## **Statement of Expert Evidence: Urban Design**

**Draft Planning Scheme Amendment GC81:**

**Fishermans Bend Planning Review Panel**

26 March 2018

Figure 1: Proposed built form strategy, from the Urban Design Strategy (p.89)

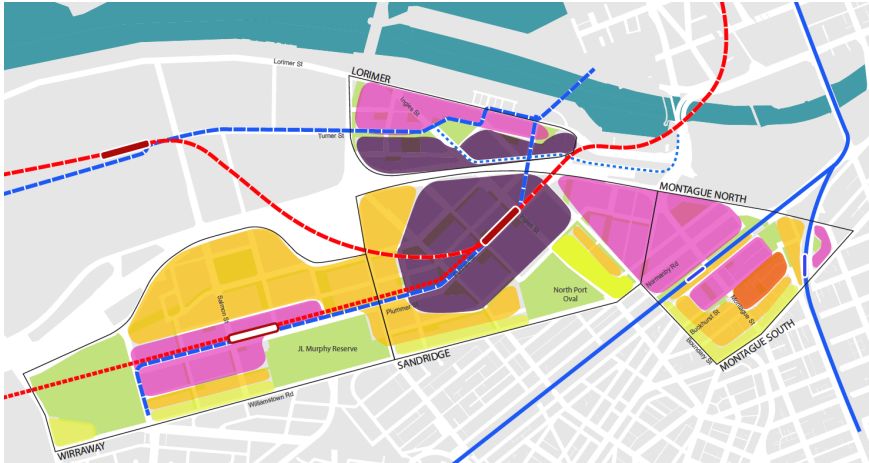
(238) I understand and observe that the heights recommended by the Urban Design Strategy and Framework have largely been carried through to the proposed DDO30.

Figure 2: Proposed height limits, from the Urban Design Strategy

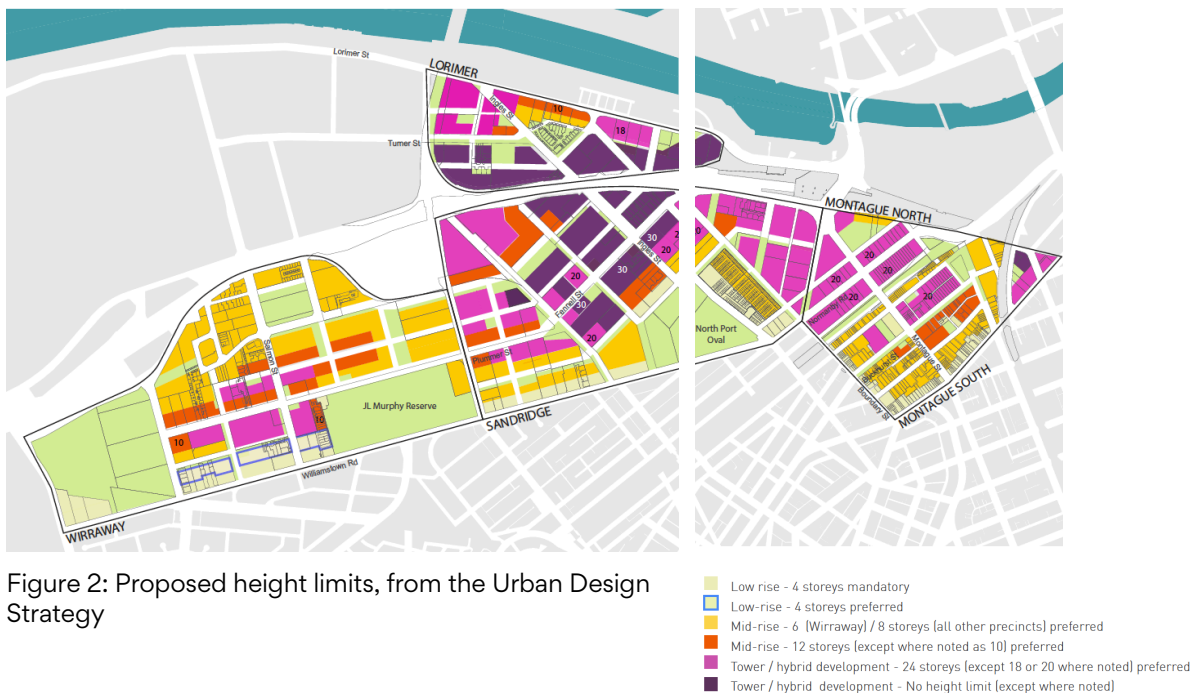
(255) I am also satisfied with the transition to tower/hybrid built form types in the northern parts of Sandridge, which extend to approximately 550m from the intersection of Plummer and Fennel Streets. The transition to the south occurs quite rapidly, with potential for 20 storeys approximately 130m from Williamstown Road, grading down to 8 storeys then 4 storeys.

(256) The 4-storey mandatory interface to Williamstown Road appears to be approximately 50m deep. As in Montague, I am comfortable with limiting the frontage to this 4-storey scale, in response to the low-scale residential context to the south. However, given the width (30m approximately) and traffic load of Williamstown Road, and the existing interface to industrial buildings, I would recommend that this control should be discretionary, with a mandatory frontage height of 4 storeys and mandatory upper level setback of 10m. This interface needs to balance a sensitive transition/interface, with clear demarcation of a different urban condition north of Williamstown Road.

- (261) Change the mandatory 4-storey control for the southern interface of Montague facing City Road and Boundary Street, to discretionary, with mandatory 4-storey frontage and minimum 10m upper level setbacks.

- (262) Change the mandatory 4-storey control for the southern interface of Sandridge and Wirraway facing Williamstown Road, to discretionary, with mandatory 4-storey frontage and minimum 10m upper level setbacks;
